SERVICE BULLETIN

BULLETIN: 02-06

SUBJECT: 43SB GALLEY AIR CONDITIONING DUCT HOSE

GALLEY
DUCT
HOSE

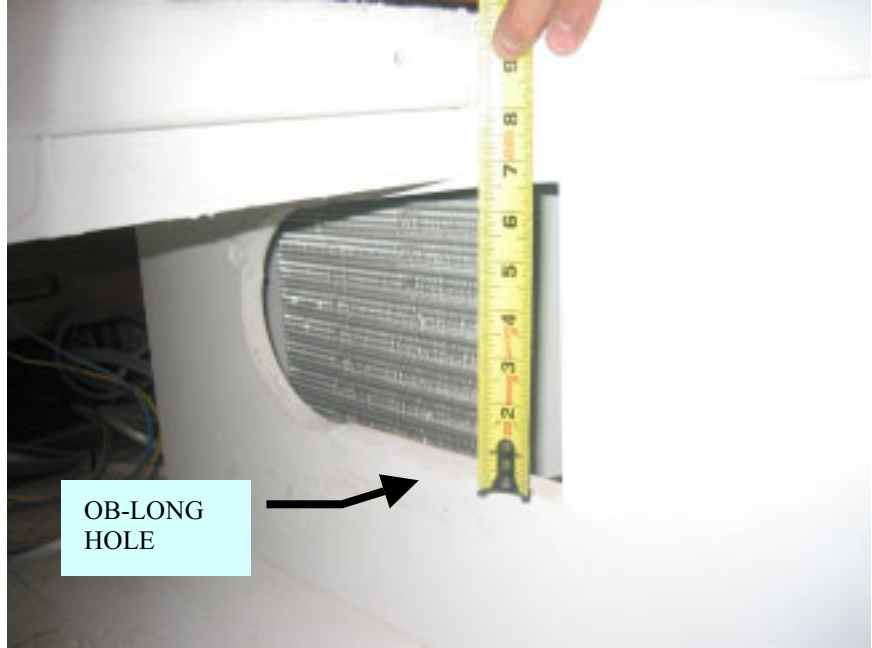
It has recently been brought to Silverton's attention when installing the mid air conditioning unit, the duct hose running to the galley may have been crushed.

- 1- Remove air condition hatch located in the STBD. Mid state room.
- 2- Remove galley duct hose from air cond. unit and pull duct hose through into galley floor compartment. (See photo below)
- 3- With a jigsaw ob-long hole where duct hose passed through bulkhead so duct hose is inline with plenum box on air cond. unit. (See photo below) (Before cutting hole be certain that there are no hose or wires in area to be cut and the blade on saw will not hit the AC unit.)
- 4- Pass duct hose back through hole and re-attach to AC unit.

OB-LONG
HOLE
